**Subject: Response to ESPO Memorandum  
EPA ID NO: CAD009164021**

Project 207530 – Response to DTSC Letter to Martinez Refining Company (MRC) dated February 26, 2020 regarding Recommendations for the ETP-1 Biotreater Dike Stability Assessment Report for Martinez Refining Company LLC, Martinez, California. EPA ID. No. CAD 009 164 021

# **SGH Response to the DTSC February 26, 2020 Letter Comments**

Figure 1: U.S. Geological Survey and California Geological Survey, Quaternary fault and fold database for the United States, accessed June 8, 2020, at: <https://www.usgs.gov/natural-hazards/earthquake-hazards/faults>.

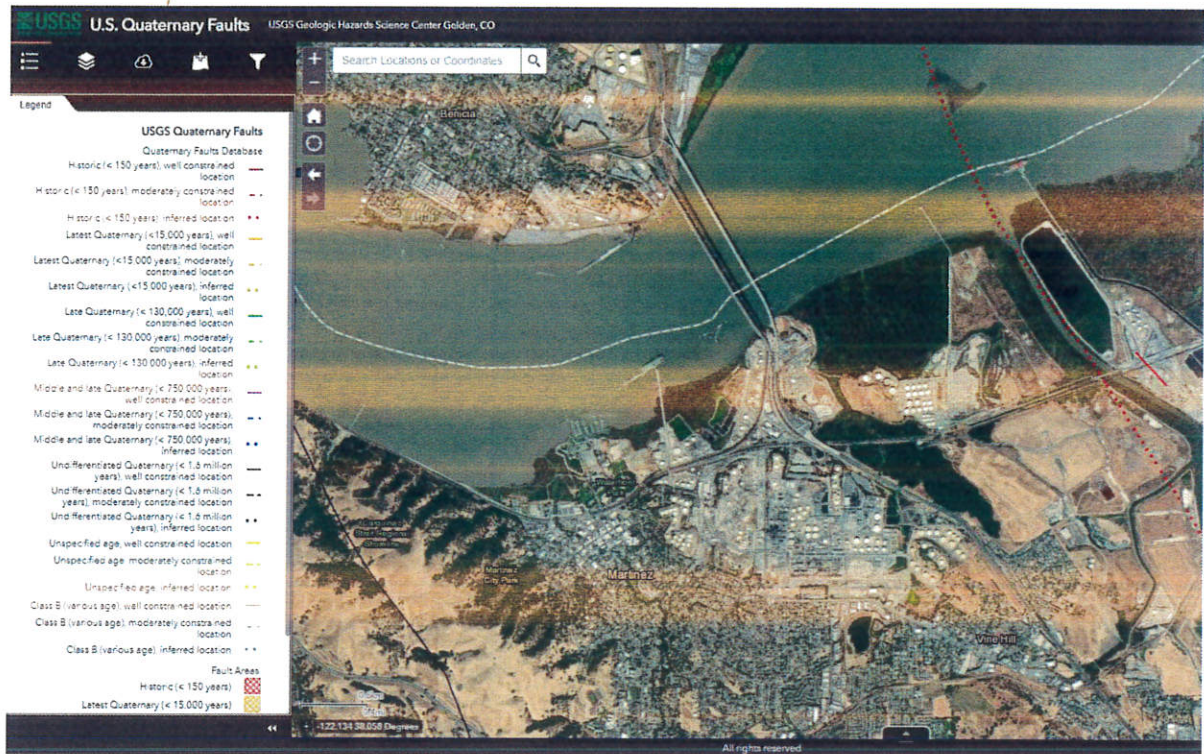
3. **Section 2.4.1 Woodward-Clyde Consultants, "Evaluation of Holocene Faulting in Vicinity of the CO Boller Waste Feed Tank Shell Oil Company Martinez Refiner, Martinez, California," dated 12 May 1989.** We note that this report was issued almost 31 years ago, and the information in it is likely outdated. The report should be reviewed against current knowledge and practices in the seismic practice and any deficiencies should be addressed via an update or a new report.

The current USGS maps showing Quaternary Faults do not indicate known or suspected faults through this facility.

Figure 1 below shows a portion of the USGS interactive fault maps available online through the USGS website. The nearest fault is the main trace of the Concord Fault (in Red), approximately 2 miles to the E-NE of the site.

Pond 7 is near the center of the image. The nearest fault is to the east and does not trend toward the site.
